No. 11 (Lot No. 98) Chetwynd Way, Booragoon WA 6154
13 Aged and Dependent Persons Dwellings

Form 1 – Responsible Authority Report
 (Regulation 12)

Figure 2: Zoning Map of the subject site.

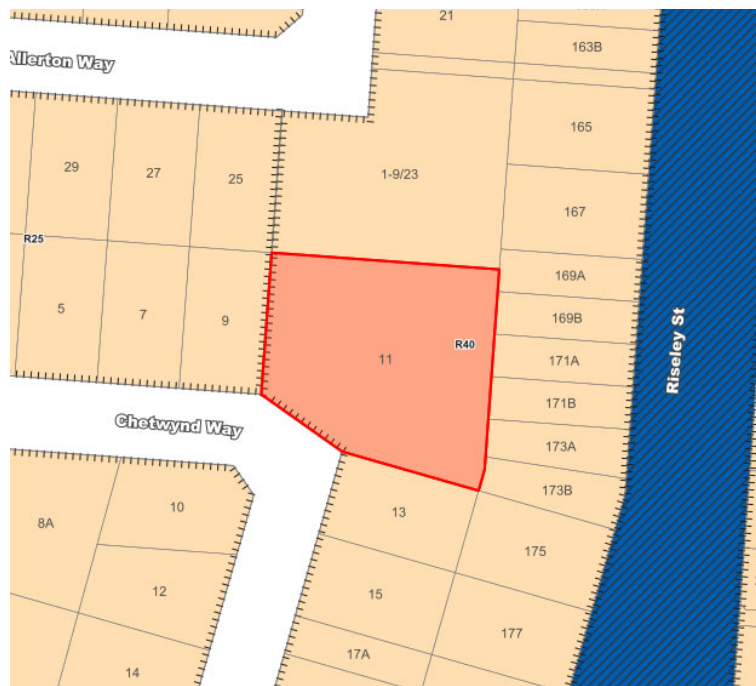
The site and those to the east are zoned Residential R40 under the City of Melville's Local Planning Scheme No.6. As demonstrated in the figure below the sites to the west are also zoned residential however these have a density code of R25.

Figure 5: Floor Plans for No. 13 Chetwynd Way with portion abutting subject development site to the top of the image (Source: REIWA)

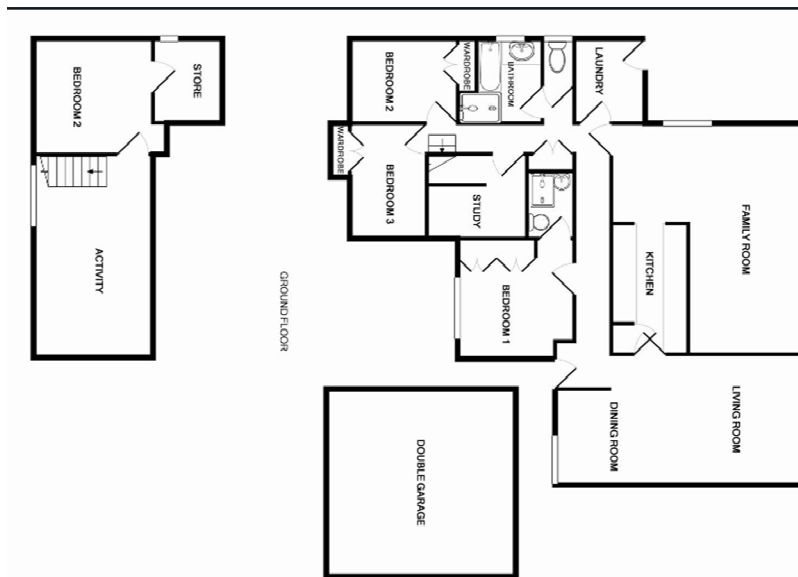
As shown in Figure 5, the major openings of the proposed southern dwellings are either orientated westward to the communal street and/or eastward towards the communal garden area. This aids in reducing the visual bulk to the adjoining southern property. In addition, the larger of the two southern boundary walls which adjoins the southern boundary at No. 13 Chetwynd Way abuts predominately utility areas (as shown in Figure 5 below), thus mitigating any bulk impact that might otherwise result.

Figure 5: Ground floor plan of 9 Chetwynd Way

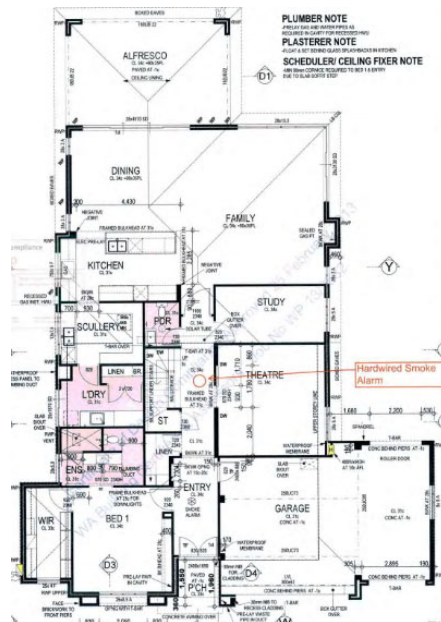
To the west, the home at No. 9 Chetwynd Way has been designed in a manner to maximise its northern aspect by having its primary living spaces open to the rear yard to the north. This alleviates the massing impact caused by the two parapet walls abutting this property as shown in Figure 5 below. In addition, solar access will not be impacted as the walls are located on the eastern boundary of that property.
